UNITED STATES PATENT AND TRADEMARK OFFICE

APPLICATION NO.	FILING DATE	FIRST NAMED INVENTOR	ATTORNEY DOCKET NO.	CONFIRMATION NO.
10/587,581	09/11/2006	Anatoli Stobbe	STOBBE-19 PCT	9668
25889 7590 10/02/2009 COLLARD & ROE, P.C. 1077 NORTHERN BOULEVARD ROSLYN, NY 11576				
EXAMINER				
HURLEY, SHAUN R				
ART UNIT		PAPER NUMBER		
3765				
MAIL DATE		DELIVERY MODE		
10/02/2009		PAPER

Office Action Summary

DETAILED ACTION

Fig. 4

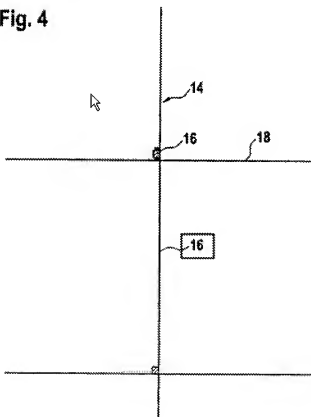
Figure 3 does not agree with figure 1 in that there are no breaks in details 12

Detail 16 in Figure 4 is incorrect:

Corrected drawing sheets in compliance with 37 CFR 1.121(d) are required in reply to the Office action to avoid abandonment of the application. Any amended replacement drawing sheet should include all of the figures appearing on the immediate prior version of the sheet, even if only one figure is being amended. The figure or figure number of an amended drawing should not be labeled as “amended.” If a drawing figure is to be canceled, the appropriate figure must be removed from the replacement sheet, and where necessary, the remaining figures must be renumbered and appropriate changes made to the brief description of the several views of the drawings for consistency. Additional replacement sheets may be necessary to show the renumbering of the remaining figures. Each drawing sheet submitted after the filing date of an application must be labeled in the top margin as either “Replacement Sheet” or “New Sheet” pursuant to 37 CFR 1.121(d). If the changes are not accepted by the examiner, the applicant will be notified and informed of any required corrective action in the next Office action. The objection to the drawings will not be held in abeyance.
